Appeal of the Chief Building Official's Decision for a Sign Variance Application for Two First Party Wall Signs

207 Queens Quay West

October 22, 2026

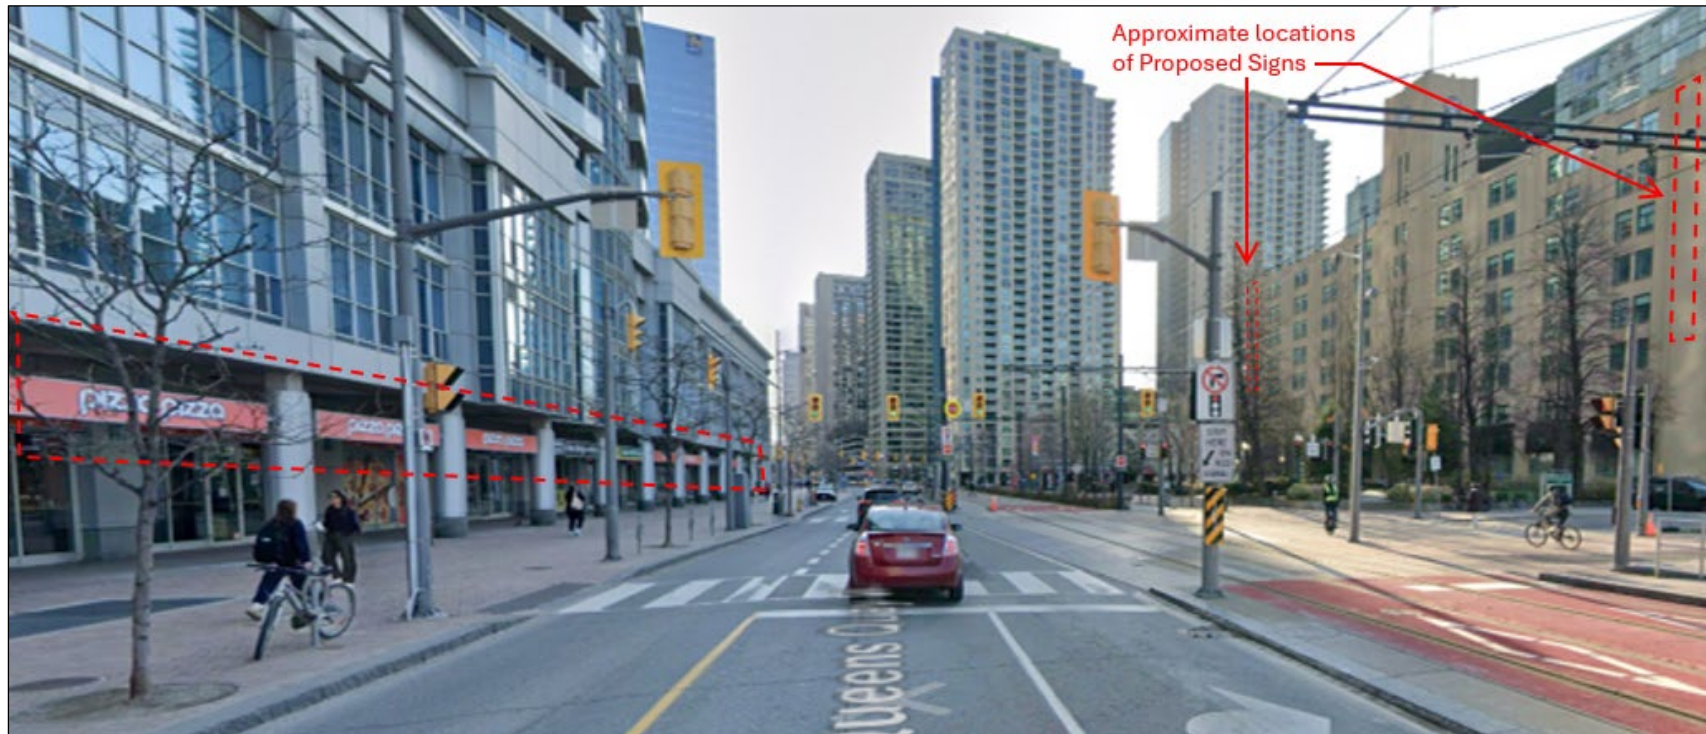
- › No reasonable basis for concern regarding pedestrian or traffic safety.

Google Street View from signage along Queens Quay W and 207 Queens Quay

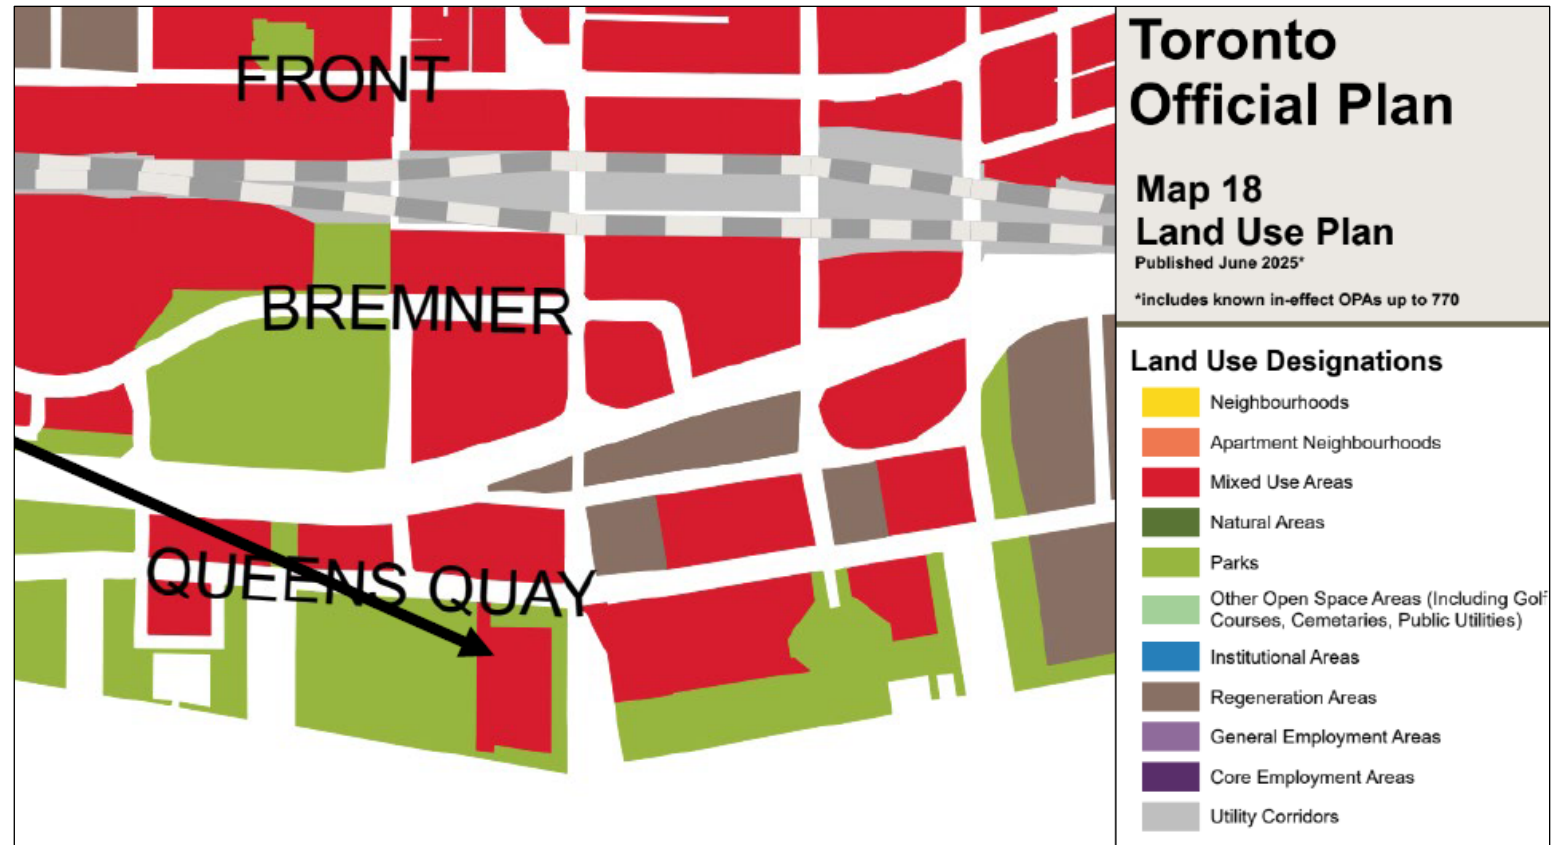
- The Proposed Signs would be significantly larger and higher than surrounding signage.
- Tree coverage is seasonal and would also screen higher signage from pedestrian visibility.
- The Proposal departs from the established signage pattern and pedestrian-oriented objectives of the CR Sign District.

› **Public feedback:** signs as visually intrusive, out of scale, and inconsistent with waterfront character.

› **CBO Opinion:** Criterion not met
